**Re: Mortdale SSD 7421 Response to Submissions**

Skylife Properties Pty Ltd has prepared a response to an email from the Department of Planning and Environment (DP&E) dated 28 June 2017 seeking clarification on matters raised by agencies relating to the Mortdale RTS from:

Figure 1: Storage bays

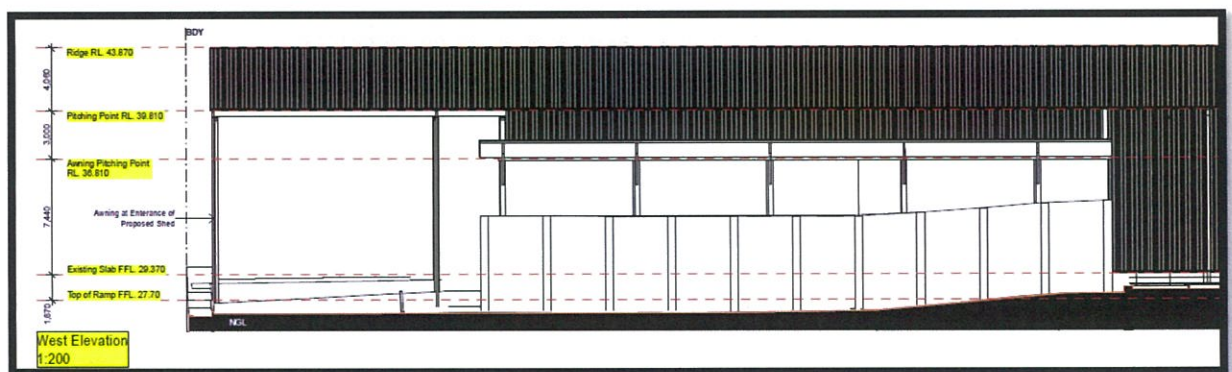
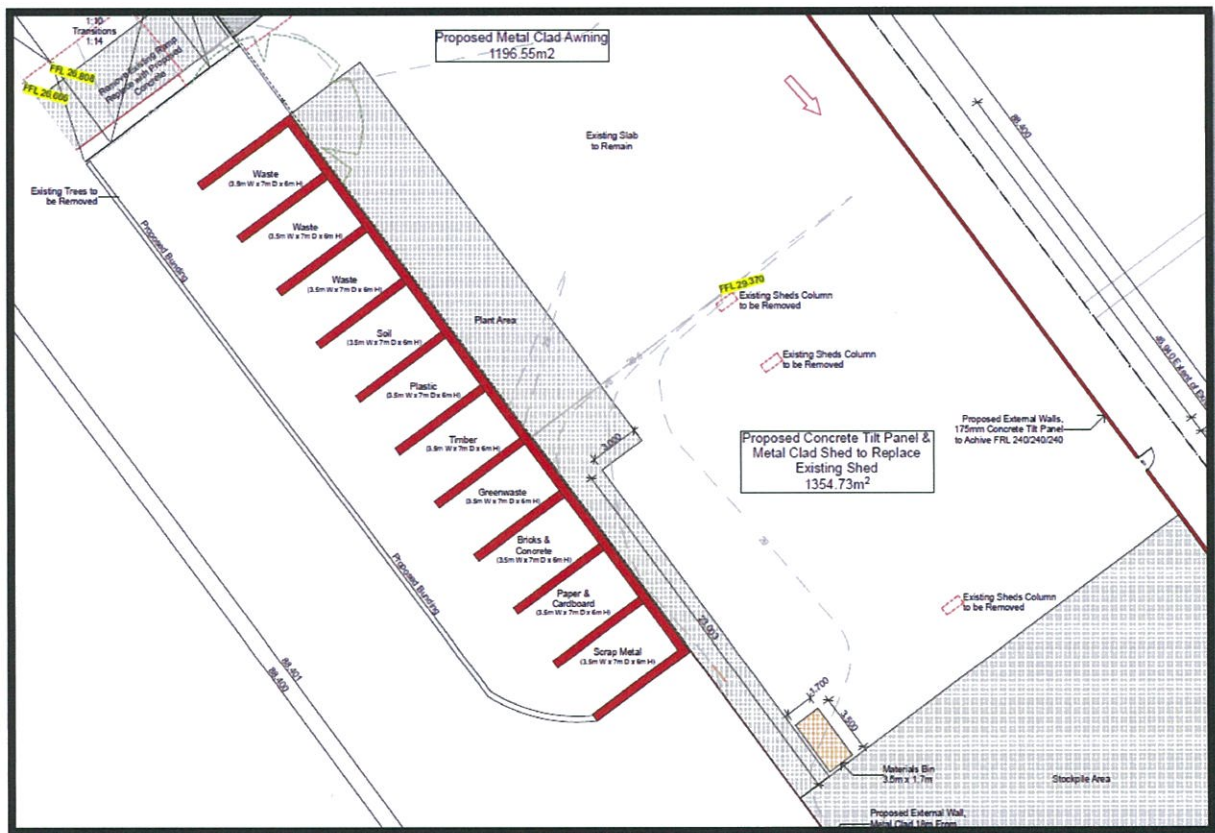
- From the diagrams provided, the design of the storage bays is such that they cannot contain a 6m high pile of waste material within. The dividing walls appear to be less than 6m high and the upper deck retaining wall (that forms the back wall of the bays) is quite low. Therefore, waste stacked to 6m could escape from the bays from all sides.
- In addition, Tables 3 and 4 of the RTS assume that the stockpiles could be fully stacked to 6m high and are thereby able to store 147m<sup>3</sup> of material each. Unless the stockpiles are fully enclosed in boxes filled to the brim, this is not practically achievable. It would therefore seem that the stockpile capacity of the site has been overestimated and should be revised.

- The architectural plans at **Appendix A** have been updated to reflect:
  - the dimensions of the storage bays at 3.5m wide X 7m depth X 6m high = 147m<sup>3</sup> (**Figure 1**);
  - plant area (**Figure 2**); and
  - a materials bin within the shed for plasterboard (**Figure 2**).
